Product Change Notification

New version of the Ultra-Slim 34 Series printed circuit board relay

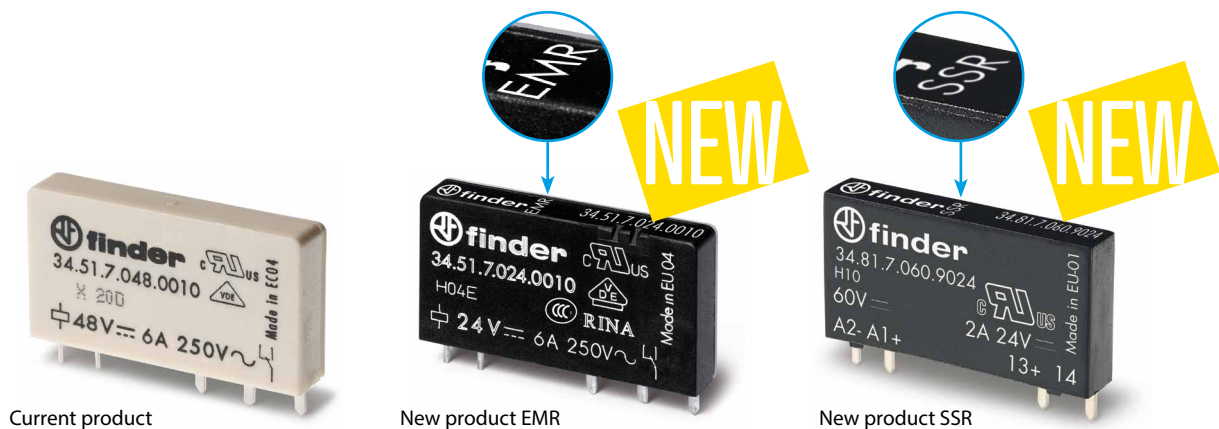
The reasons for the change: greater precision in the cover welding process.

The manufacturing process involving ultrasonic welding of the relay cover has been changed to utilising the very latest laser welding techniques.

This new procedure has necessitated a change in the plastics used for the cover of the EMR (Electromechanical Relay) version.

This change has also made possible the improved readability of the essential technical data on the product. All new versions of the Ultra-Slim 34 Series will in fact be identified as either EMR or SSR (solid state relay), as appropriate, and carry the full product code.

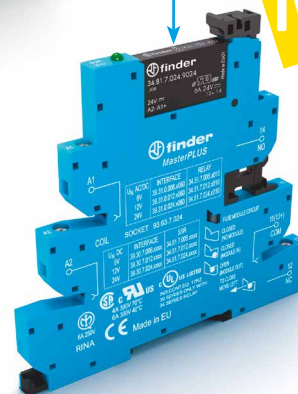
- From May 2017, the EMR relays will be produced with a black side to the cover on the front and translucent on the back
- The side of the relay is printed with the technical data, full product code and the Finder brand
- The top of the cover is printed with the Finder brand, relay type (EMR) and full product code
- The technical characteristics and approvals will remain the same as those of the previous types with the white cover.

- The cover remains completely black, differentiating it visually from the EMR relays
- The side of the relay is printed with the technical data, full product code and the Finder brand
- The top of the cover is printed with the Finder brand, relay type (SSR) and full product code
- As with the previous types, cURus approval, with the new features, has been maintained.
